UNITED STATES PATENT AND TRADEMARK OFFICE

APPLICATION NO.	FILING DATE	FIRST NAMED INVENTOR	ATTORNEY DOCKET NO.	CONFIRMATION NO.
10/680,560	10/06/2003	Tuoc Tan Nguyen	816020-100044-US	4130
34026	7590	10/05/2005	EXAMINER	
JONES DAY 555 SOUTH FLOWER STREET FIFTIETH FLOOR LOS ANGELES, CA 90071			MILLER, CHERYL L	
			ART UNIT	PAPER NUMBER

Office Action Summary	Application No. 10/680,560	Applicant(s) NGUYEN ET AL.	
	Examiner Cheryl Miller	Art Unit 3738

DETAILED ACTION

FIG. 7

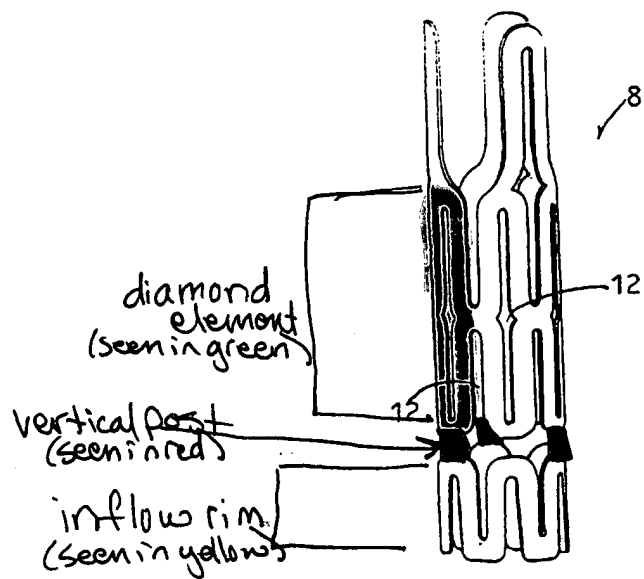
outflow annulus (fig.10, 11), and an expandable and collapsible anchoring structure (8; fig.7-9) dimensioned to extend longitudinally from an inflow attachment location to an outflow attachment location, the anchoring structure (8) comprising a singled flared inflow rim (18; there is only one inflow rim) and only three flexible vertical posts (posts extending from 18, seen in fig.7-9, particularly in fig.7; only three are shown) extending from the inflow rim (18) in a direction toward the outflow annulus of the valve (6) wherein the vertical posts further comprise a single diamond shaped (opening 14; there only being *one* opening 14 associated with each vertical post, see attachment 1) element having no direct contact with the replacement valve (there is no contact, since the anchoring structure 8 is flared away from the valve 6, and the valve is only in contact at protrusions 36, which extend through openings 14, below the diamonds). Garrison however, discloses the inflow and outflow annulus to be straight rather than scalloped. Myers teaches in the same field of valve assemblies, the use of scalloped inflow and outflow annuluses on replacement valves like the one of Garrison (see figures 8, 9, 17, 28, and 29), as an improvement to straight annuluses, in order to provide increased hemodynamic performance, minimized creasing, and an overall better fit within the native valve [0088-0090]. It would have been obvious to one having ordinary skill in the art at the time the invention was made to combine Garrisons heart valve prosthesis, with Myers teaching of scalloping annuluses of valve prostheses, in order to provide increased hemodynamic performance, minimized creasing, and an overall better fit within the native valve.

FIG. 9

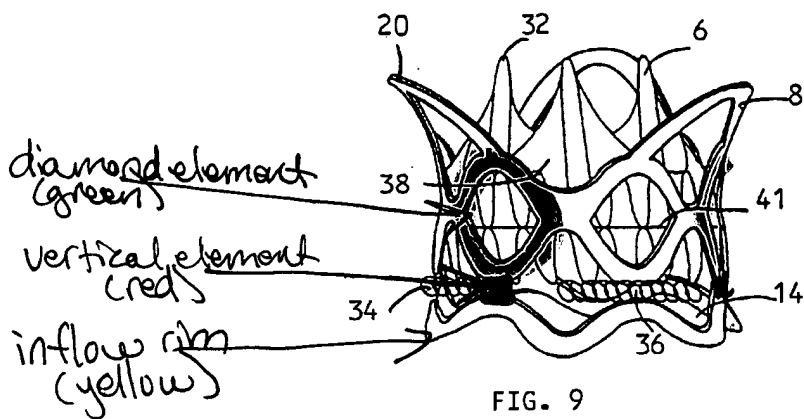
Claims 1, 3, 4, 6, and 7 are rejected under 35 U.S.C. 103(a) as being unpatentable over Garrison et al. (US 6,425,916 B1, cited in IDS) in view of Myers et al. (US 2002/0052651 A1, cited previously). Referring to claim 1, Garrison discloses a valve assembly (see fig.5, 6, 9) comprising a replacement valve (6 or 38, seen in fig.10) having an inflow annulus (41; bottom of fig.), an outflow annulus (top of fig), and a plurality of leaflets (39) in between the inflow and

FIG. 21

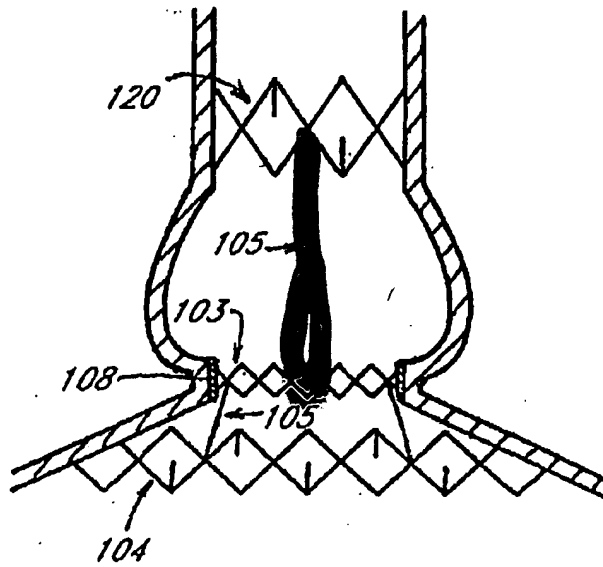
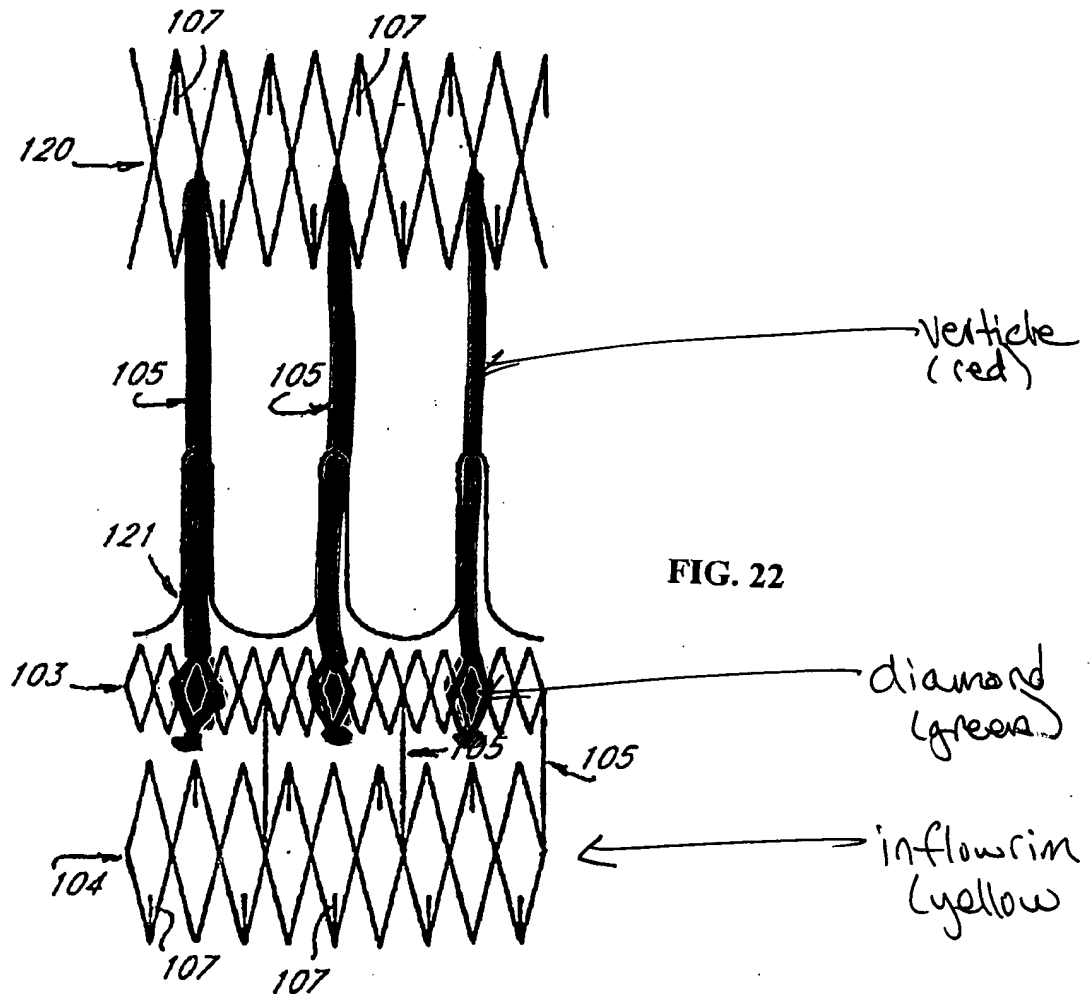
Claims 1, 3, 4, 6, and 7 are rejected under 35 U.S.C. 103(a) as being unpatentable over Seguin et al. (US 2004/0093060 A1, cited previously) in view of Myers et al. (US 2002/0052651 A1, cited previously). Referring to claim 1, Seguin discloses a valve assembly (see fig.19, 21, and 22) comprising a replacement valve (10 or 102; see fig.4, 14, and 17) having an inflow annulus, an outflow annulus, and a plurality of leaflets in between the inflow and outflow annulus (fig.4, 14, 17 and respective portions of the specification), and an expandable and collapsible anchoring structure (stent in fig.19, 21, and 22) dimensioned to extend longitudinally from an inflow attachment location to an outflow attachment location, the anchoring structure comprising a singled flared inflow rim (104+105 in figs) and only three flexible vertical posts (105a+105b+103; see attachment 2) extending from the inflow rim (104+105) in a direction toward the outflow annulus of the valve wherein the vertical posts (105a+105b+103) further comprise a single diamond shaped (portion of 103 coinciding with 105) element having no direct contact with the replacement valve (diamond is located below where the valve is placed, therefore, no contact). Seguin however, discloses the inflow and outflow annulus to be straight rather than scalloped. Myers teaches in the same field of valve assemblies, the use of scalloped inflow and outflow annuluses on replacement valves like the one of Seguin's (see figures 8, 9, 17, 28, and 29), as an improvement to straight annuluses, in order to provide increased hemodynamic performance, minimized creasing, and an overall better fit within the native valve [0088-0090]. It would have been obvious to one having ordinary skill in the art at the time the invention was made to combine Seguin's heart valve prosthesis, with Myers teaching of scalloping annuluses of valve prostheses, in order to provide increased hemodynamic performance, minimized creasing, and an overall better fit within the native valve.

Referring to claims 3, 4, 6, and 7, see figures 19, 21, and 22, and respective portions of the specification.
